MONTICELLO NUCLEAR GENERATING PLANT

AMENDMENT TO FACILITY OPERATING LICENSE

Amendment No. 56
License No. DPR-22

ATTACHMENT TO LICENSE AMENDMENT NO. 56

Figure 3.4-1 Sodium Pentaborate Solution Volume Concentration Requirements

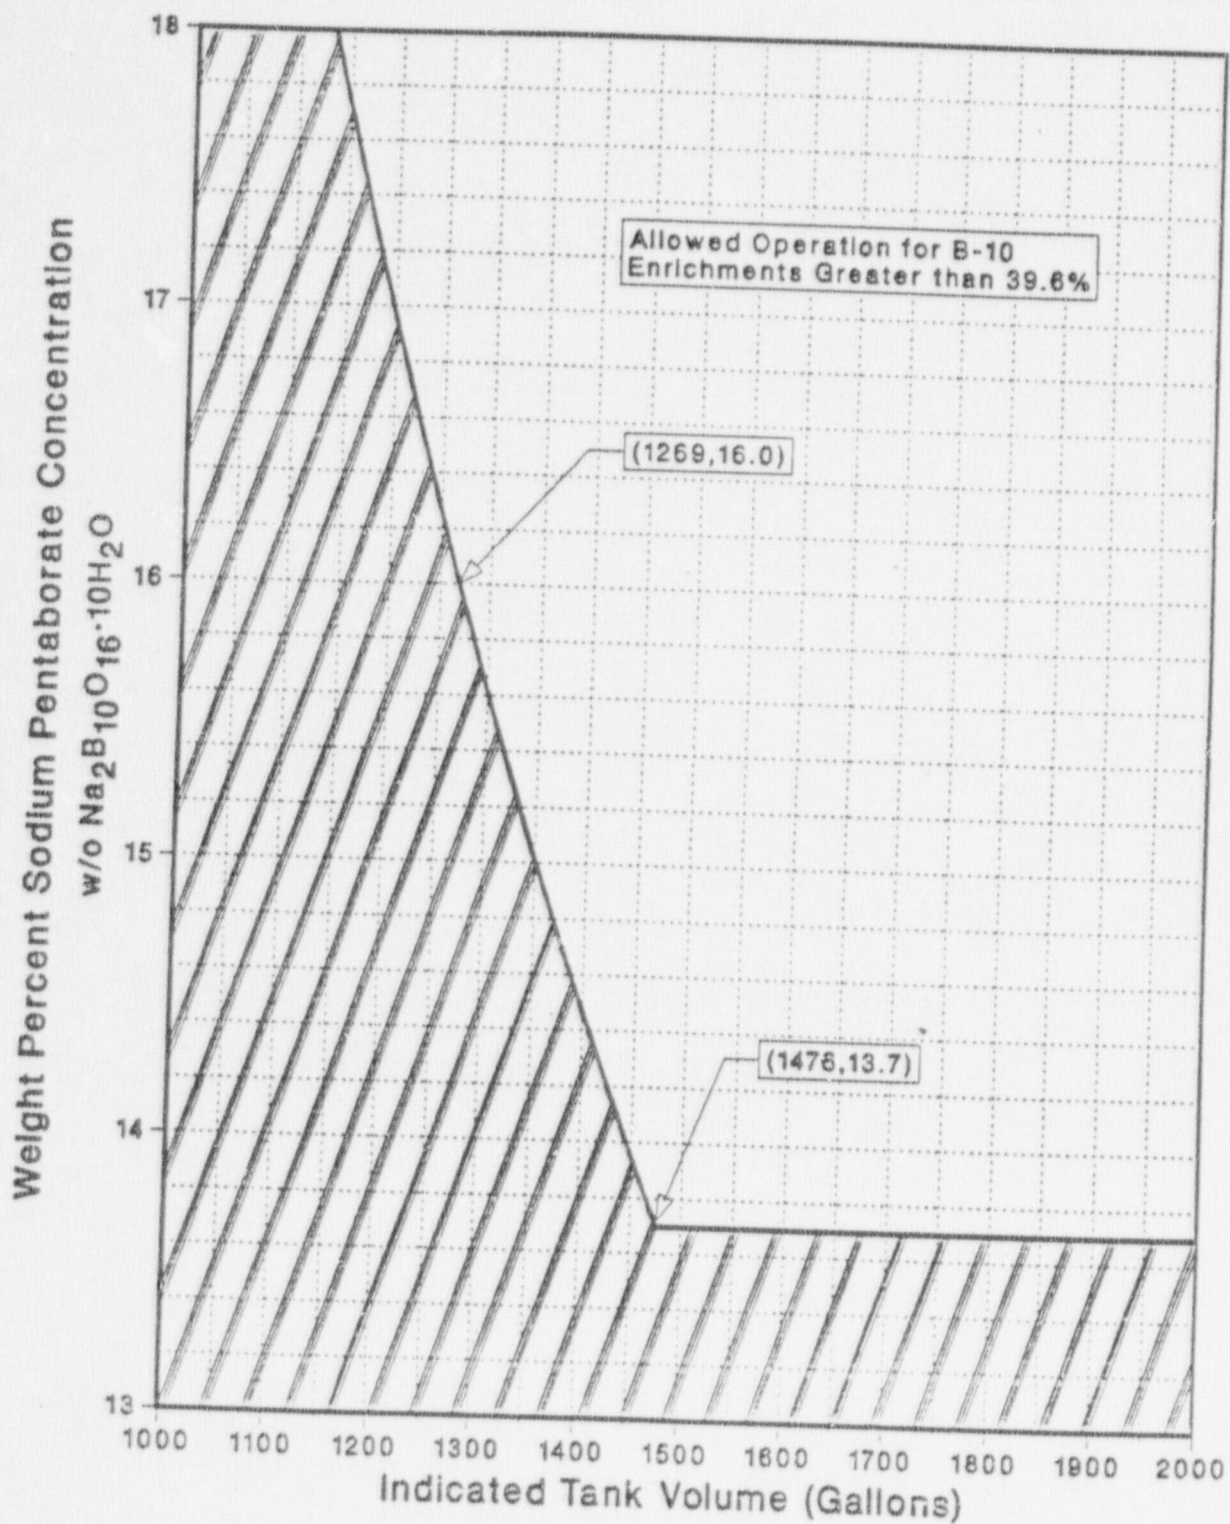
1. The liquid poison tank shall contain a boron bearing solution that satisfies the volume, concentration and enrichment requirements of Figure 3.4.1, or compliance can be demonstrated by satisfying the following equations:

Equation 1 (Original Design Basis):

$$V \geq \frac{11.18}{0.0025 \times C + 0.998} (1 + \frac{4821}{1191-E}) (\frac{19.8}{E}) (\frac{100}{C})$$

a 128 gal

Equation 2 (ATWS Design Basis):

$$C \geq 8.28 (\frac{E}{Q}) (\frac{19.8}{E})$$

- V - Boron solution tank volume (gal)
- E - Boron solution enrichment (atom%)
- C - Boron solution concentration (wt%)
- Q - measured pump flow rate (gpm) at 1275 psig

Figure 3.4-2 Sodium Pentaborate Solution Temperature Requirements

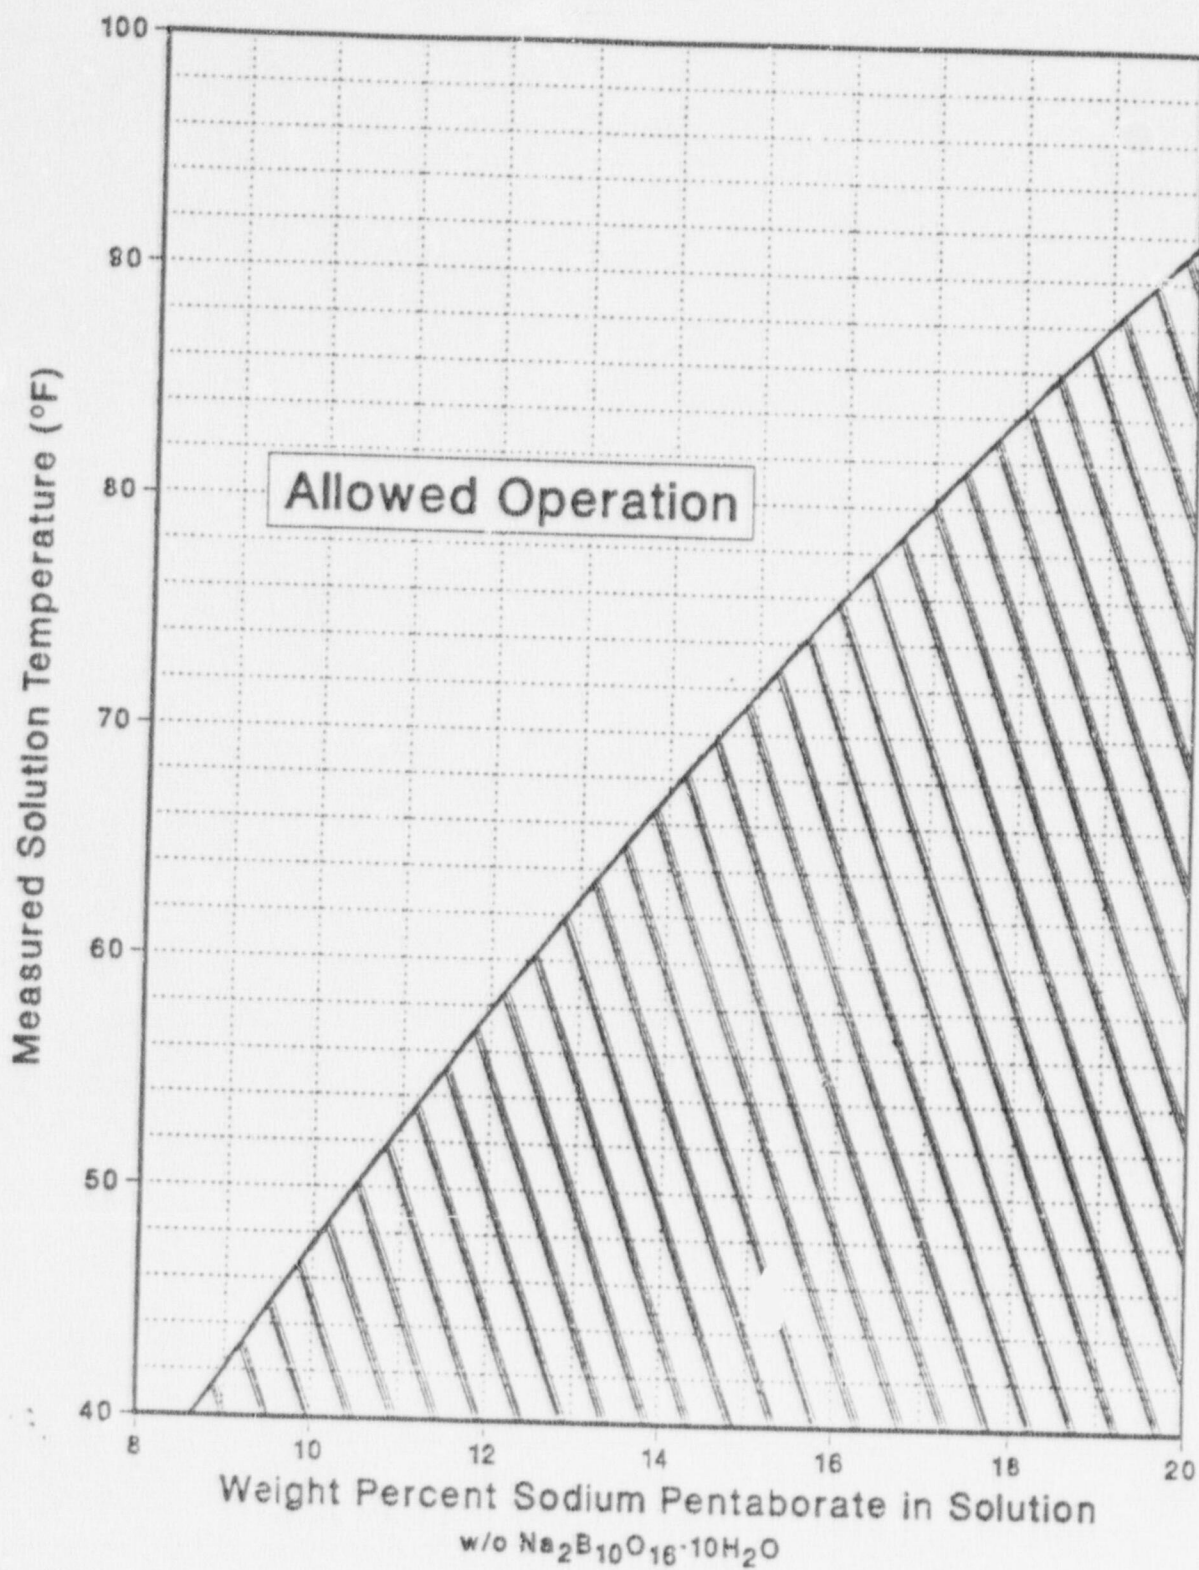
- a. Compliance with Equation 2 is demonstrated within 7 days or
- b. The Commission shall be notified and a special report provided outlining the actions taken and the plans and schedule for demonstrating compliance with the ATWS Design Basis.
2. The temperature shall not be less than the solution temperature presented in Figure 3.4.2.
3. The heat tracing on the pump suction lines shall be operable whenever the room temperature is less than the solution temperature presented in Figure 3.4.2.

- C. The solution saturation temperature varies with the concentration of sodium pentaborate. The solution will be maintained at least 5 F above the saturation temperature within the tank and suction piping to guard against precipitation. The 5 F margin is included in Figure 3.4.2. Temperature and liquid level alarms for the system are annunciated in the control room.
